February 28, 2019

RE: Application by Tarpon Towers II, LLC ("Tarpon") and Bell Atlantic Mobile Systems of Allentown, Inc. d/b/a Verizon Wireless ("Verizon Wireless") for the approvals necessary to construct and operate a 184' wireless telecommunications tower (with 4' lightning rod) and associated improvements on land owned by Calcam Associates, Inc. located off Wurtsboro Mountain Road (S.B.L. # 35-1-34) in the Town of Thompson, Sullivan County, New York (Verizon Wireless' "Louise Marie" site)

NY1137
LOUISE MARIE

1
C-5
OUTLET PROTECTION
SCALE: 1/2" = 1'-0" (11x17 SIZE)
1" = 1'-0" (22x34 SIZE)

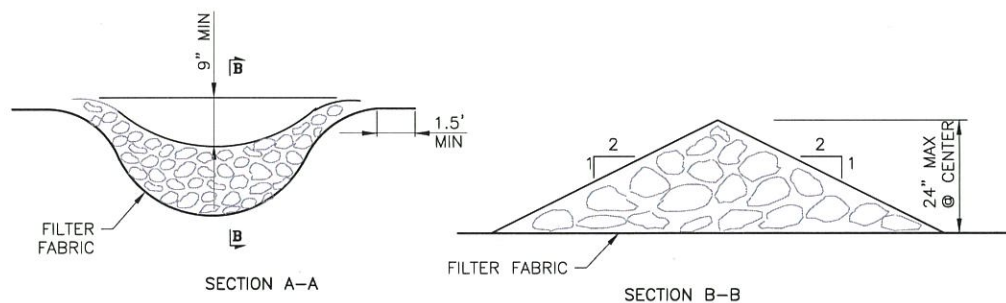
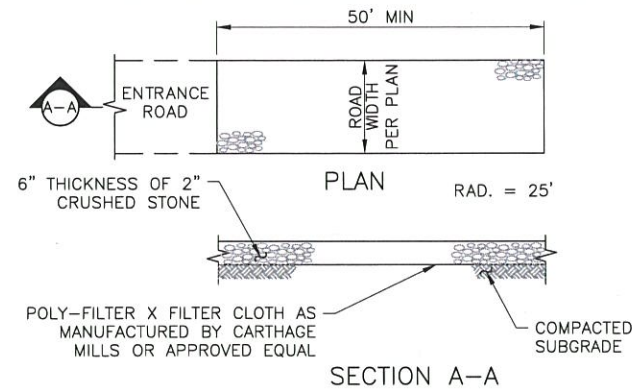
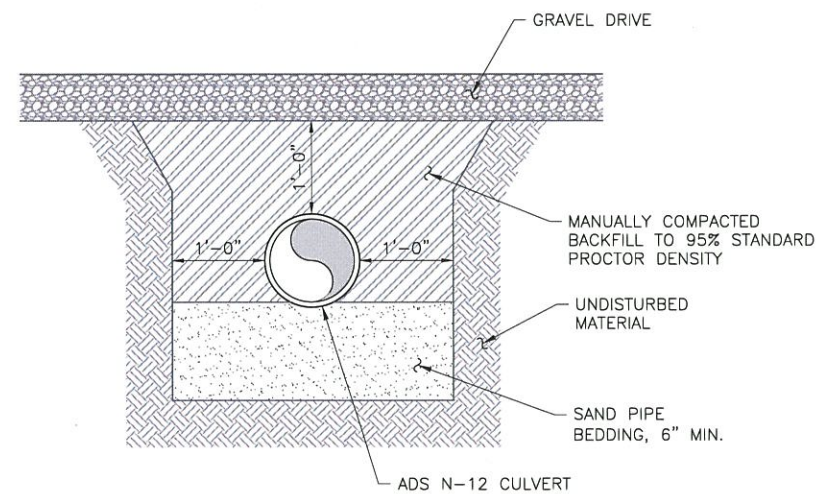
6. *The 9% grade on the access drive will require stabilized swales which should be detailed on the plans.*

Response: The requested detail is shown on Sheets C-1B, C-5, and C-6 of the Revised Plans. The new access road will create a "berm" so to speak for water naturally flowing off the top of the hill toward the W/NW. We have designed the access road with a drainage swale on the south side to capture this runoff and two culverts will divert the water under the new access road so the water can continue the natural drainage path to the W/NW. The drainage swale is a grass lined swale with stone check dams. The new access road is superelevated to pitch water into the swale. For this reason we have only designed for a swale on one side of the road (as opposed to both sides) as it captures all the runoff associated with the construction of the road.
